ST. JOHNS RIVER WATER MANAGEMENT DISTRICT
ENVIRONMENTAL RESOURCE PERMIT #40-069-114354-1
RAI Submittal

HARTWOOD MARSH ROAD
PHASE II

Re: Hartwood Marsh Road—Phase II
1500 feet East of Hancock Road to Orange County Line
Application Number 40-069-114354-1
Response to Request for Additional Information

**POND DETAIL SHEET
 PONDS 3A & 3B**

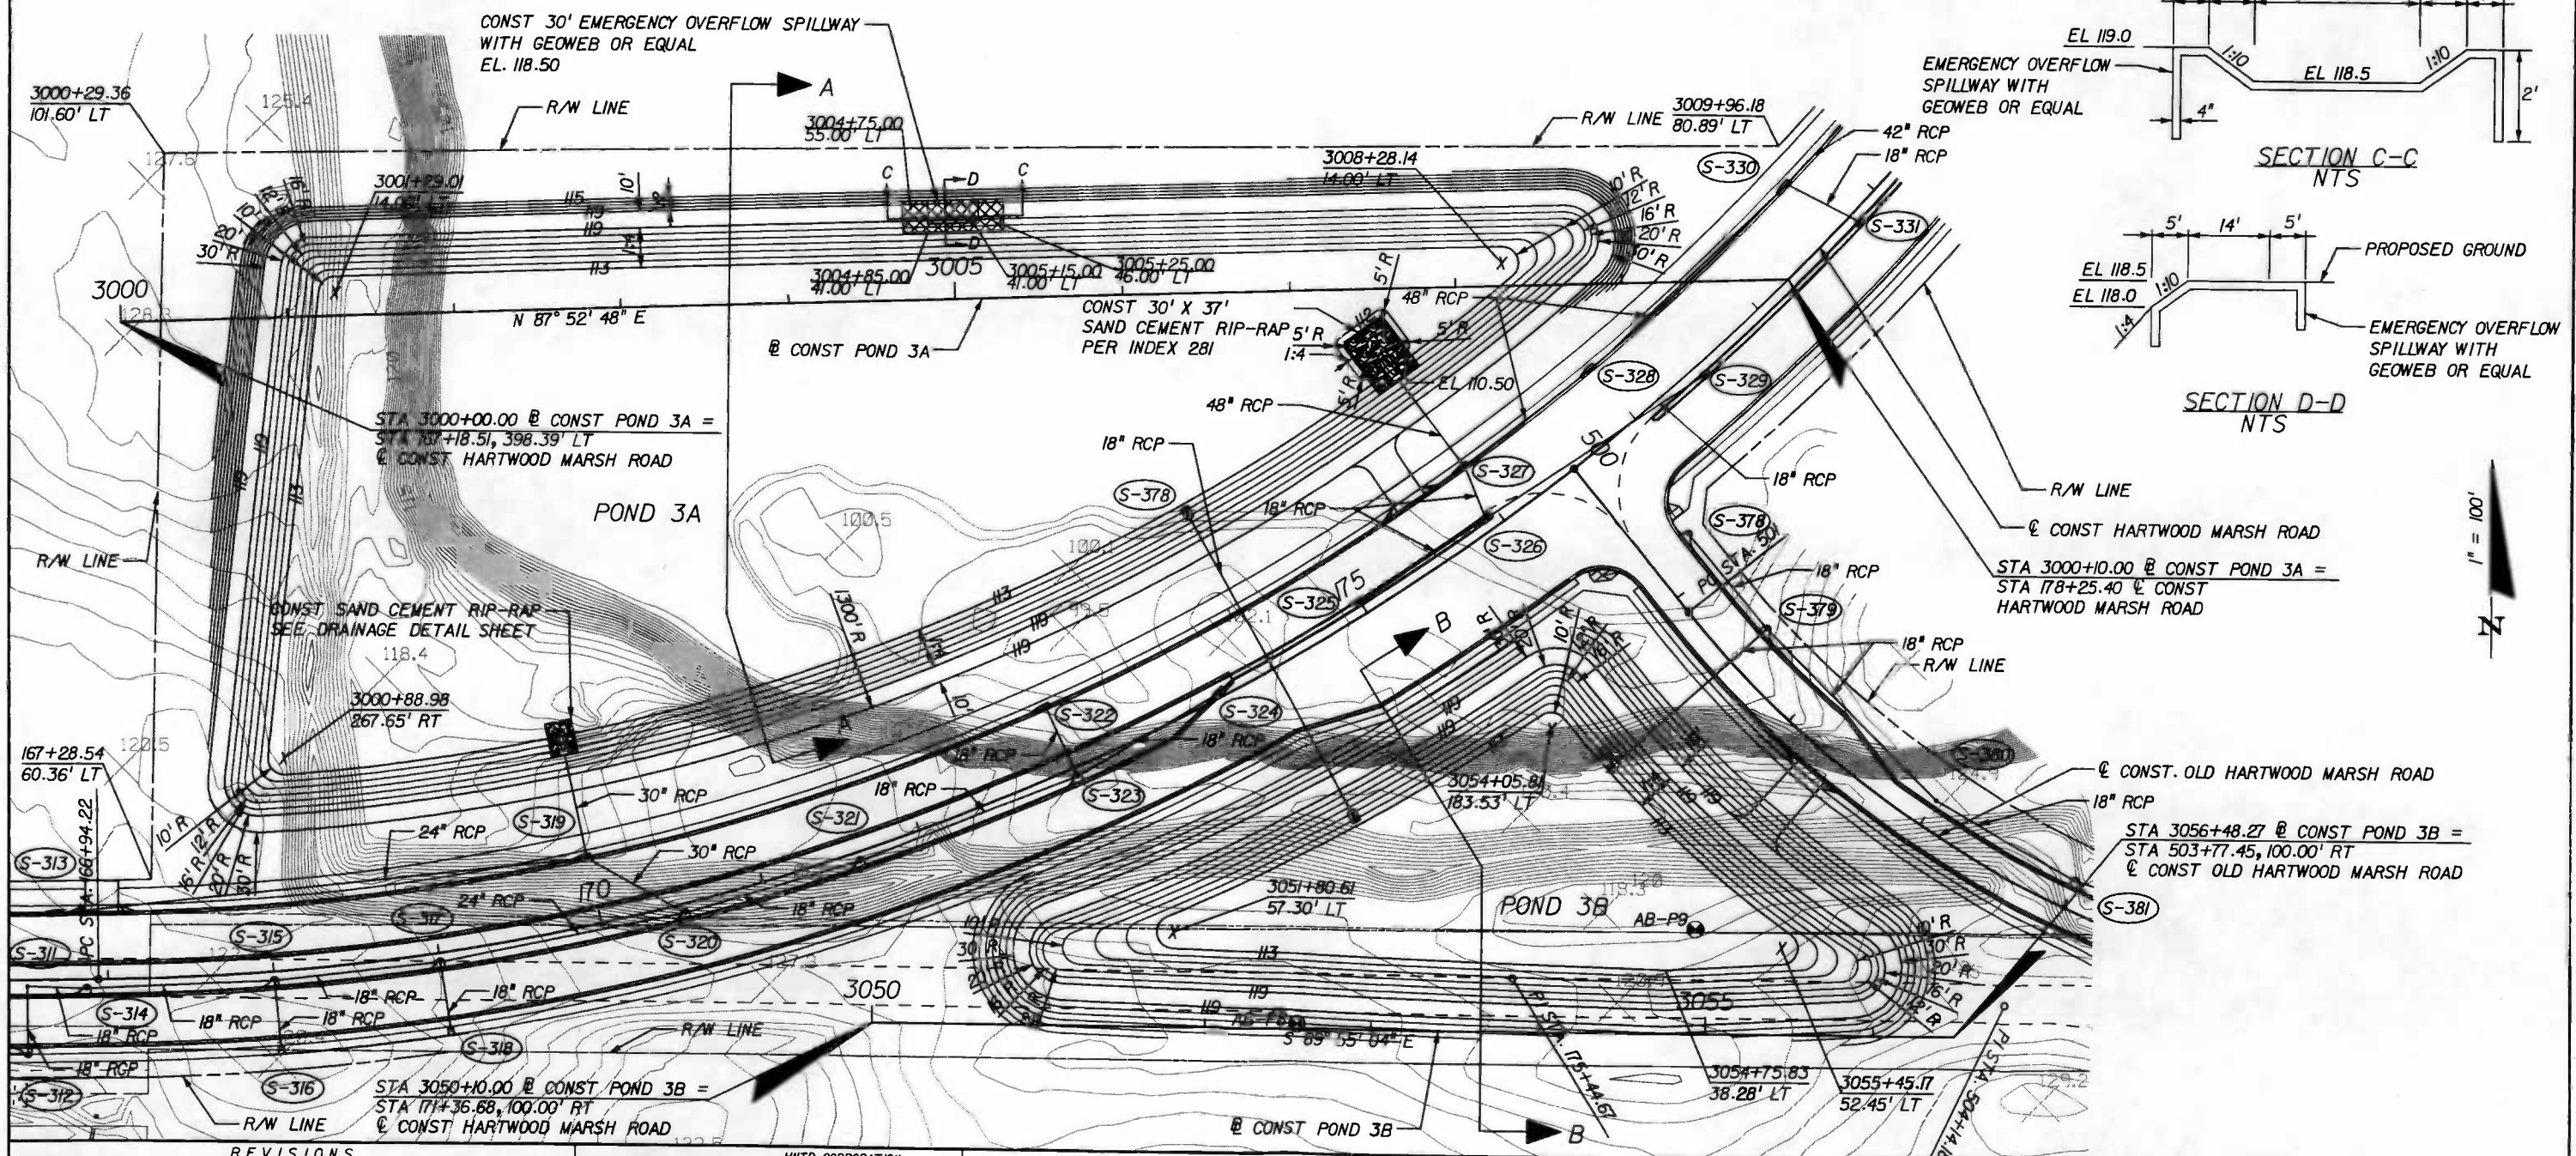
Comment 1: Comment No. 1 of the RAI was not adequately addressed. In demonstrating that Pond 3 (interconnected Ponds 3A and 3B) is designed in accordance with District water quality treatment criteria and land locked criteria, please address the following:

- a. The revised calculations indicate that the basin area and impervious area for Pond 3 are 48.67 acres and 15.89 acres, respectively, which equates to a treatment volume of 4.06 ac-ft. The submitted PONDS recovery analysis; however, was based on a treatment volume of 2.27 ac-ft, which is incorrect. Accordingly, please provide a revised PONDS recovery analysis

demonstrating that the required treatment volume will be recovered within 72 hours.

- b. The entire runoff volume for the 25-year, 96-hour storm event is 25.66 ac-ft according to the ICPR storm routing analysis included with the initial submittal. The storage capacity in the pond appears to be 24.33 ac-ft based on a weir invert elevation of 118 feet. The submitted PONDS recovery analysis for the storage capacity was based on a volume of 25.56 ac-ft. Accordingly, please clarify the storage capacity for Pond 3. If the intent is to retain the entire runoff volume generated by the 25-year, 96-hour storm event, please provide revisions indicating such.
- c. The base of aquifer (BOA) and seasonal high water table (SHWT) elevations currently assumed in the PONDS recovery analyses are inconsistent with the calculated values shown on page 10 of the report. Accordingly, provide revised recovery analyses for consistency with the calculated values shown.

- a. *The treatment volume has been corrected in the PONDS analysis and the pond will recover within 72 hours. Please refer to the drainage calculations.*
- b. *The weir invert has been raised to 118.5 feet giving a total volume of 27.20 ac-ft of available storage.*
- c. *The BOA and the SHWT have been corrected in the recovery analysis to match the calculated values. The ponds will recover in the required time. Please refer to the drainage calculations.*

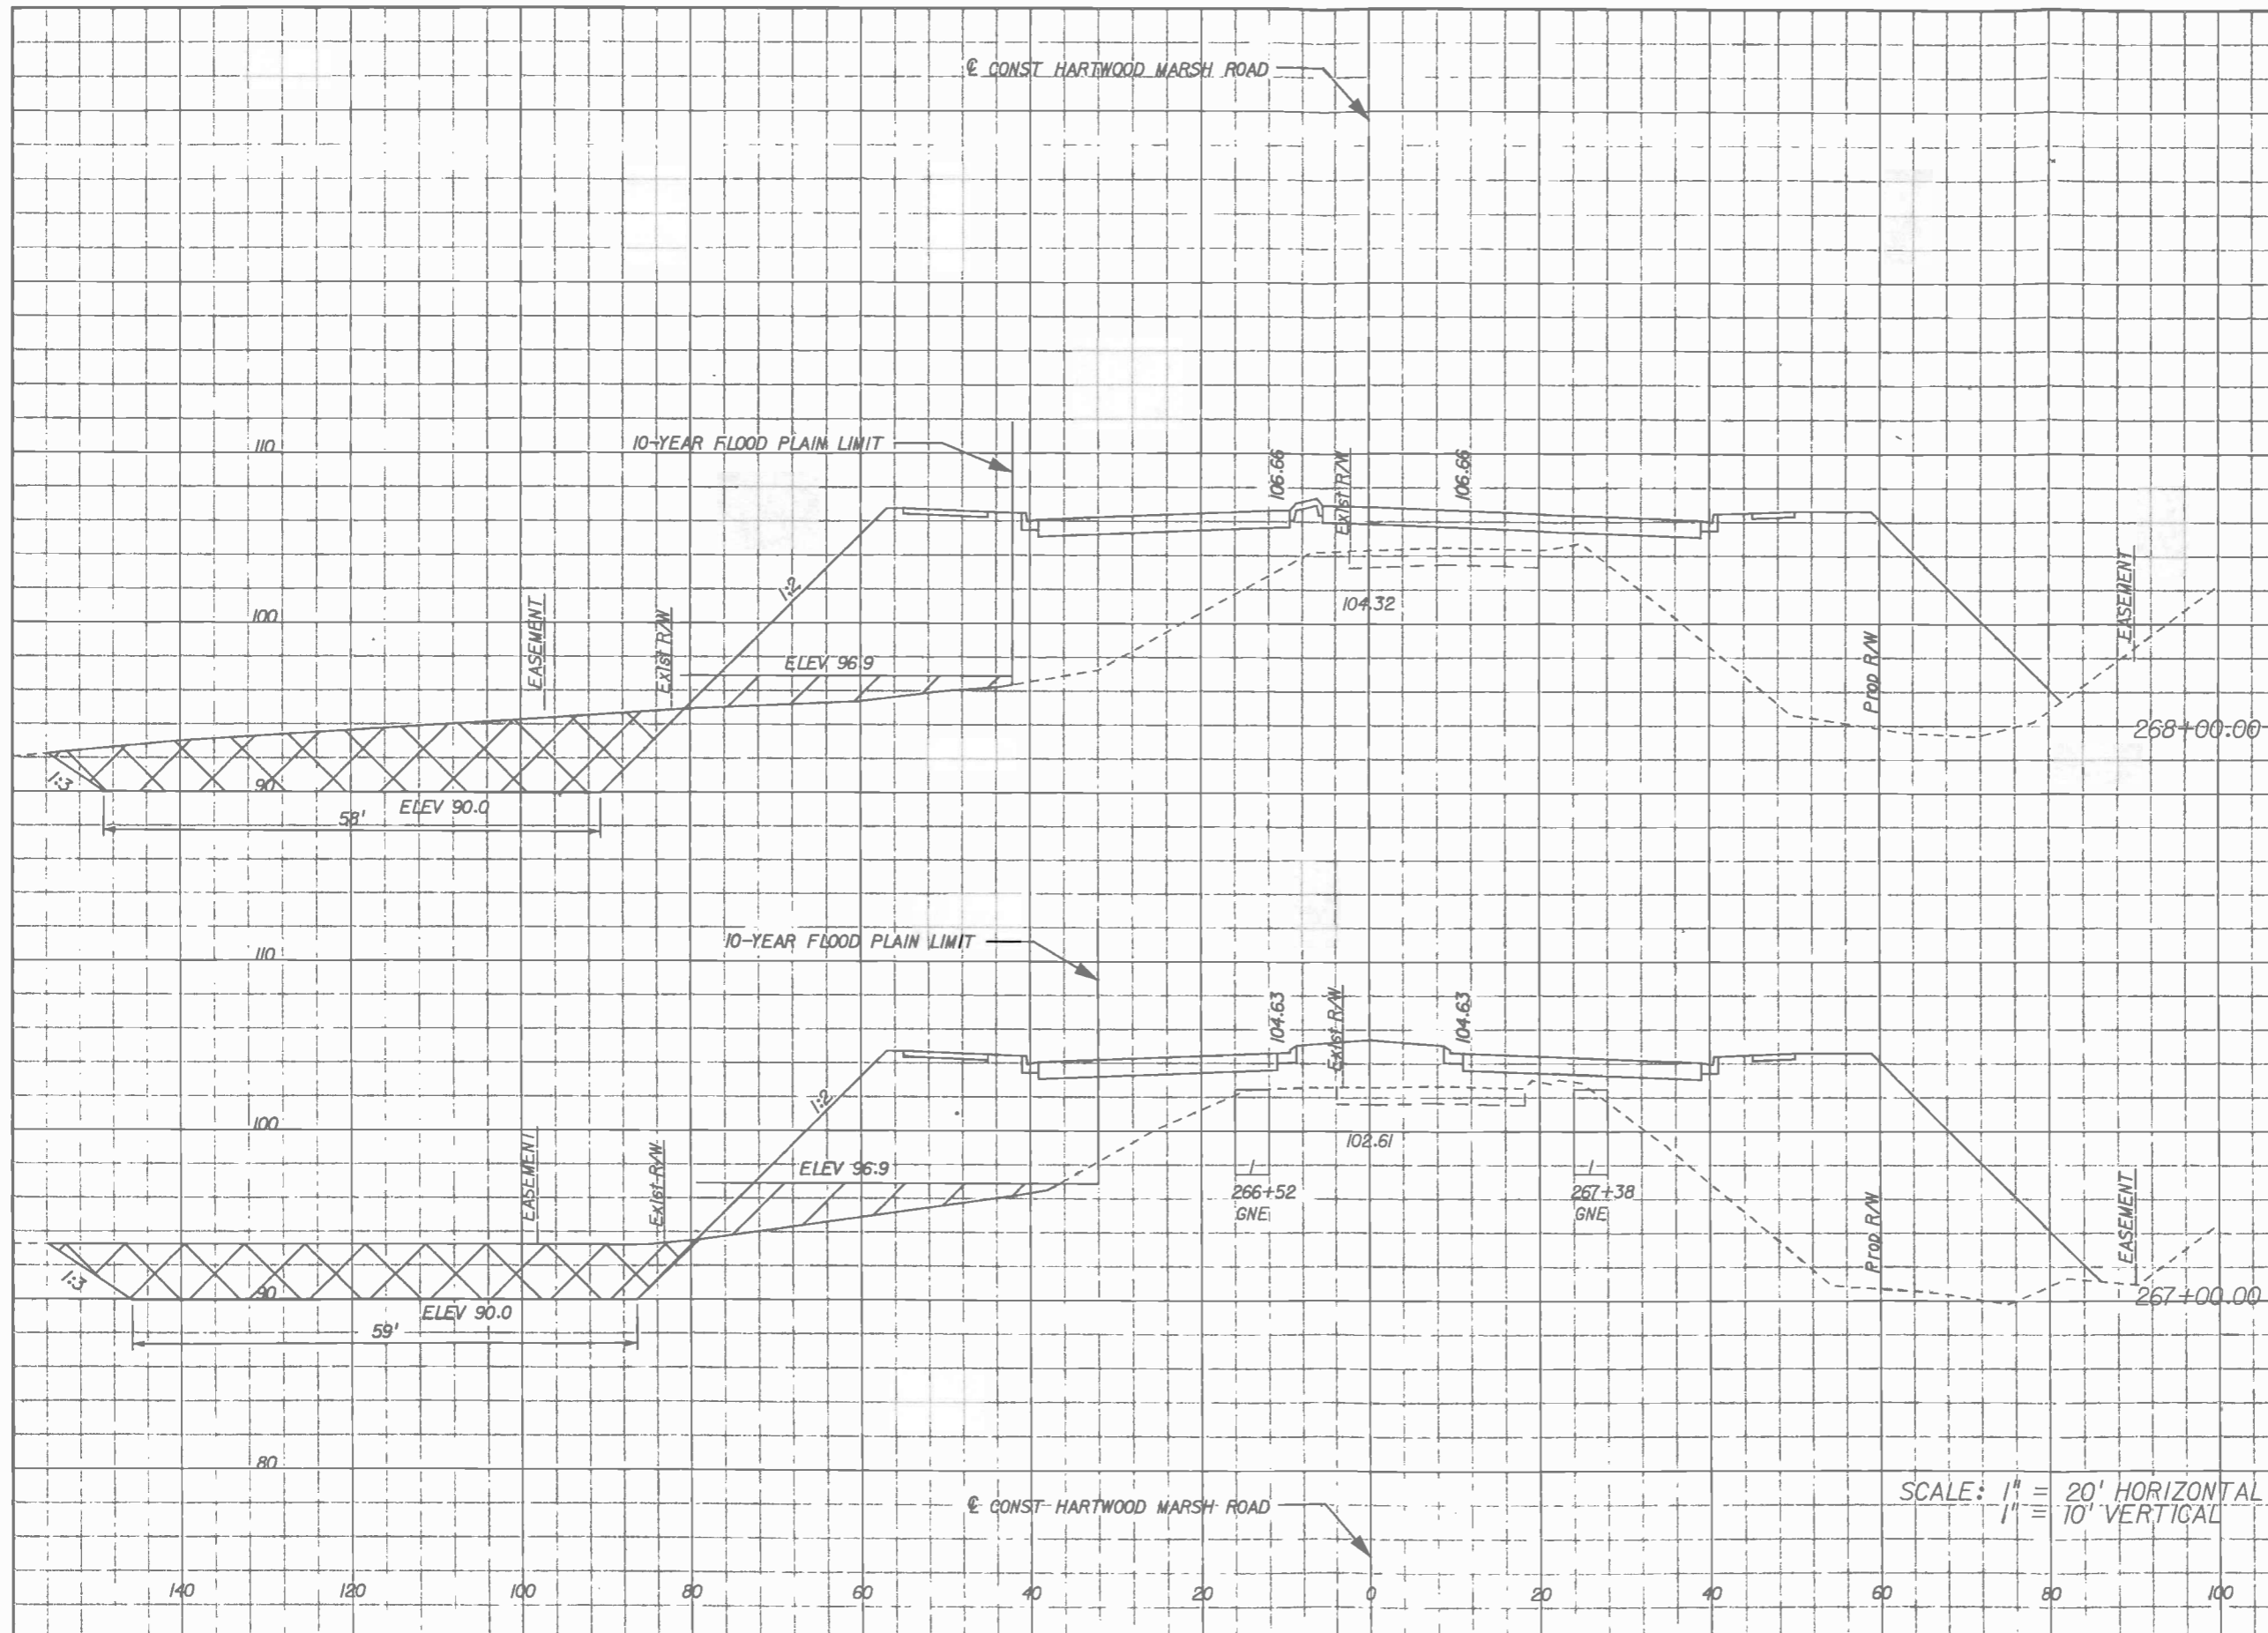
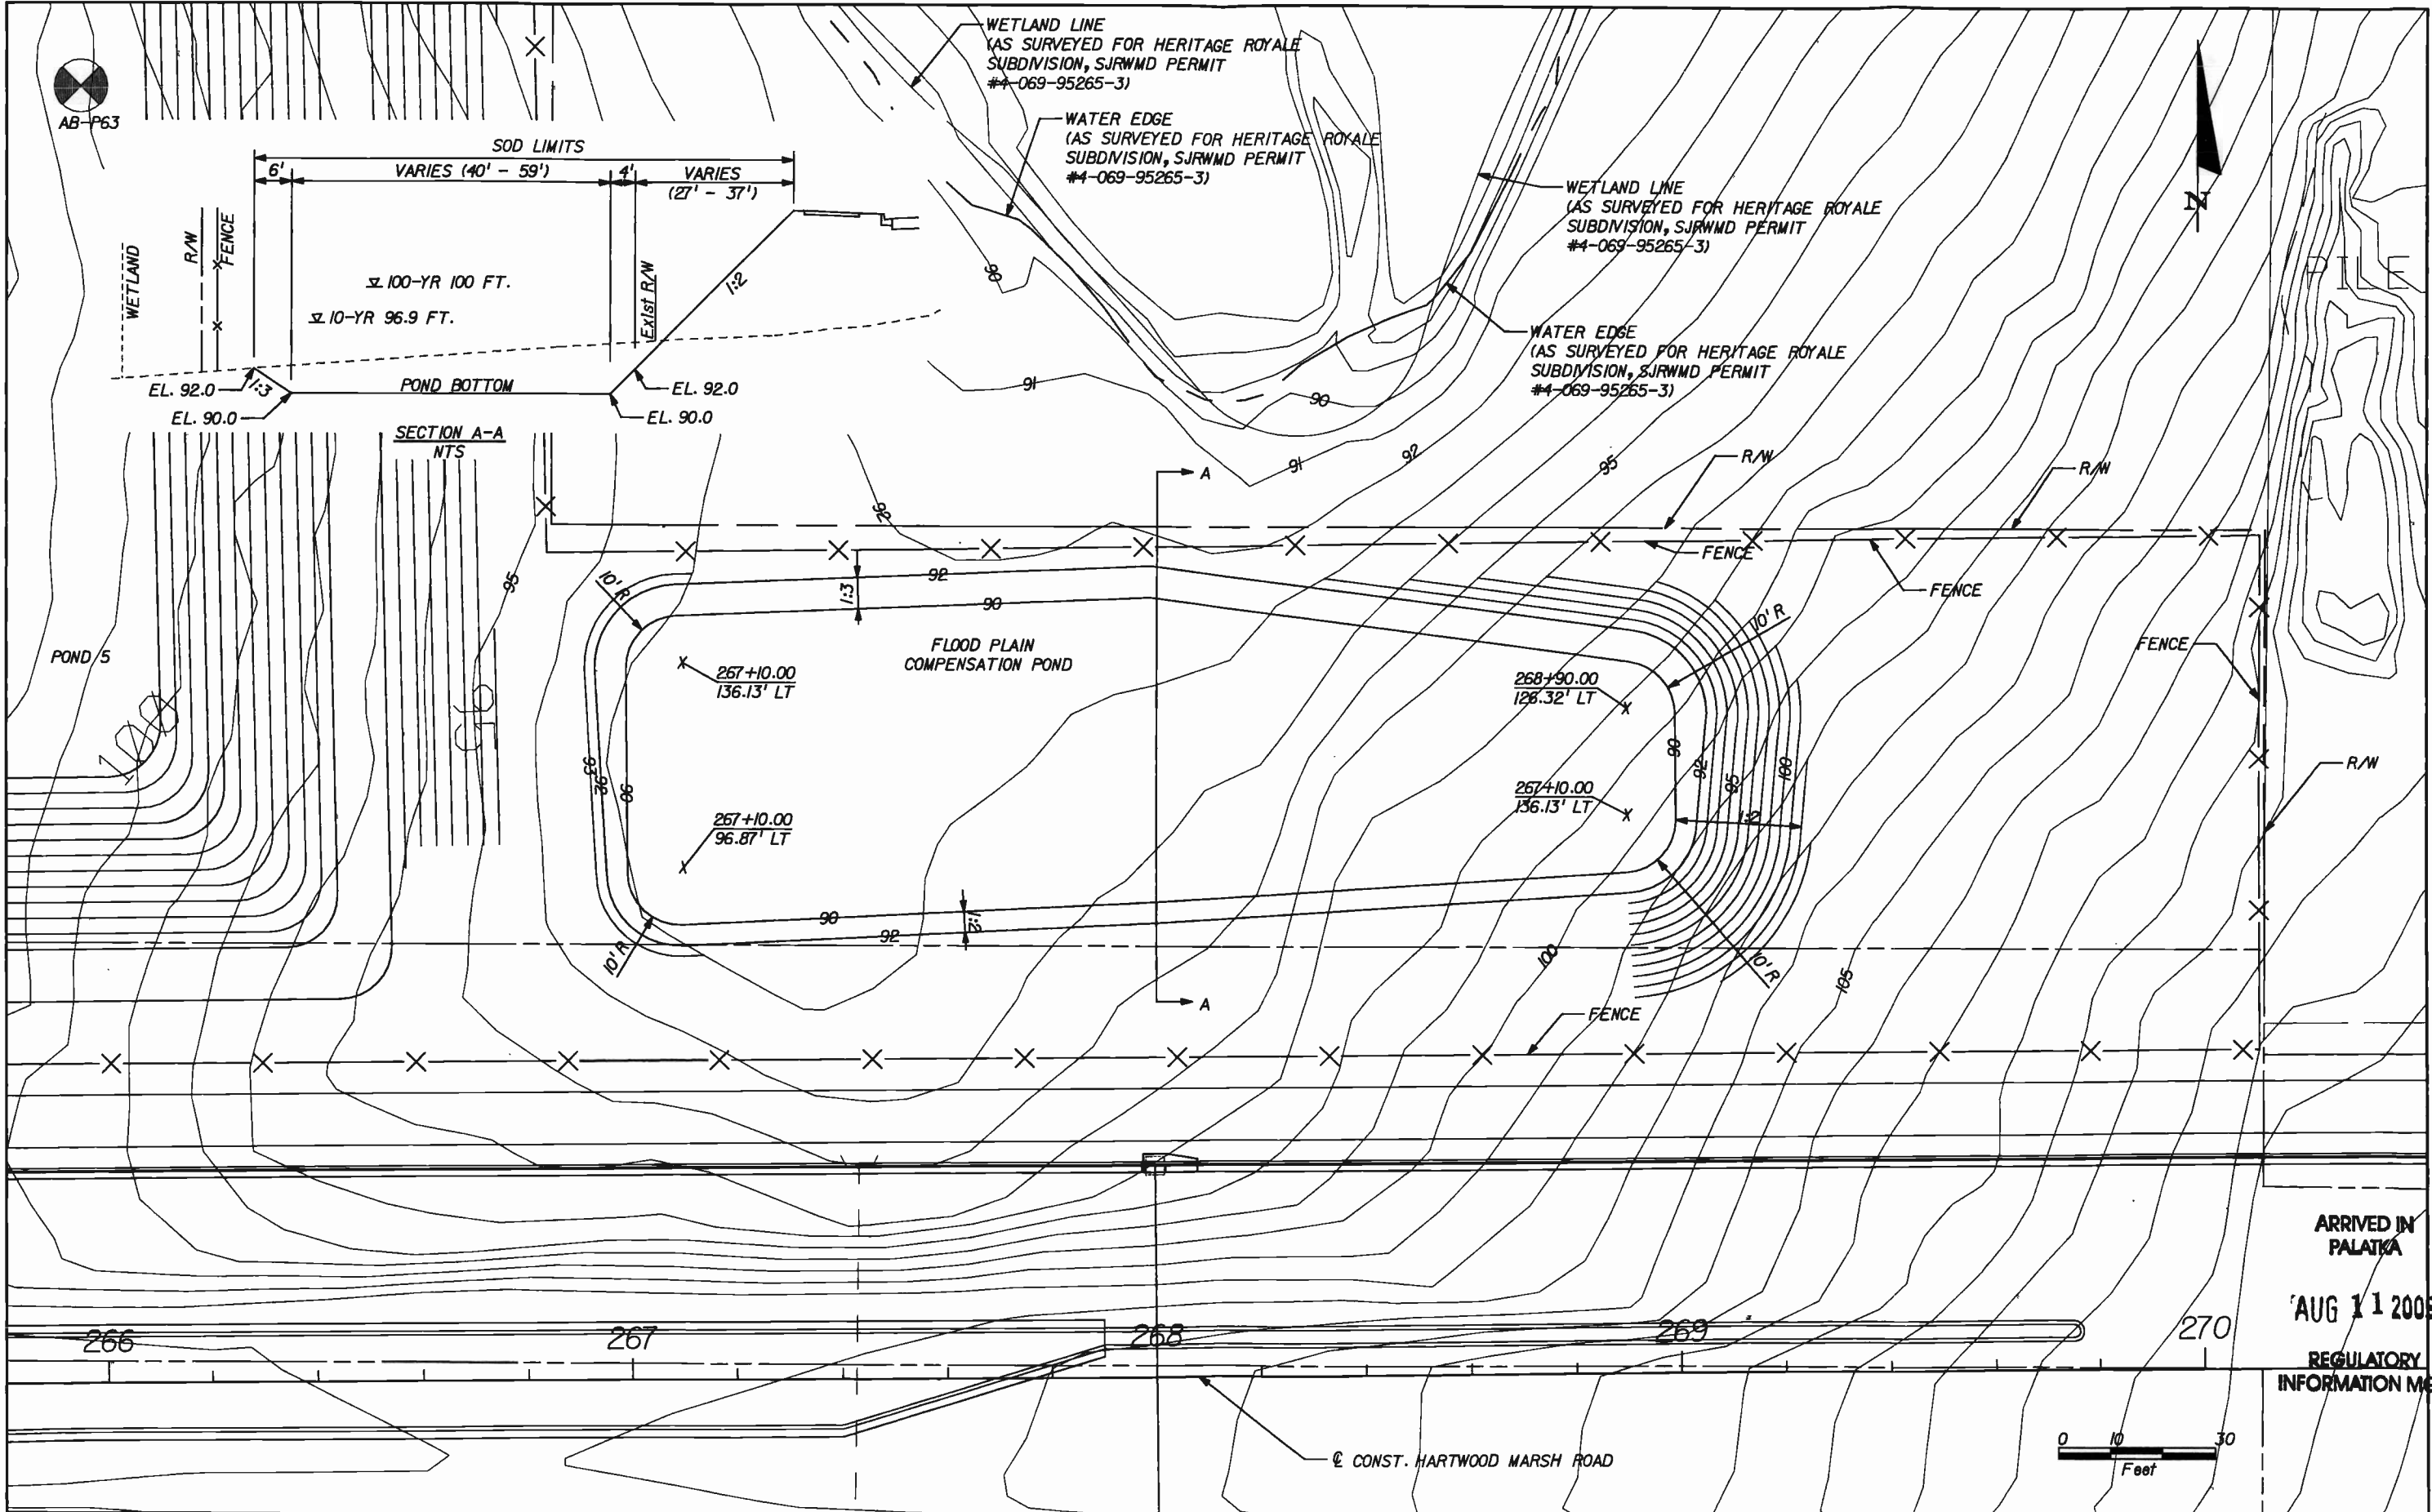
In addition, please provide cross-sectional view details for the compensating storage pond demonstrating that the pond is sufficiently sized to compensate for the fill impacts within the 10-year flood plain as shown in the cross-sectional view details on Pages 46 and 47 of the report. Please include supporting documentation for the SHWT elevation for the compensating storage pond, as previously requested, so that the compensating storage volume may be verified. Also, the compensating storage pond must have an open hydraulic connection to the floodplain encroached upon and the storage must be available during the flood event. The construction plans provided are not clear in this regard. Provide plan revisions and details, as necessary, for clarification.

Response: *The 10-year flood plain elevation of 96.9 feet NAVD for Johns Lake came from the 2002 FEMA Flood Insurance Study. The Summary of Stillwater Elevations table from the study has been included in the drainage calculations for reference. A pond detail sheet has been included for the compensation pond as well as calculations. Please refer to the drainage calculations.*
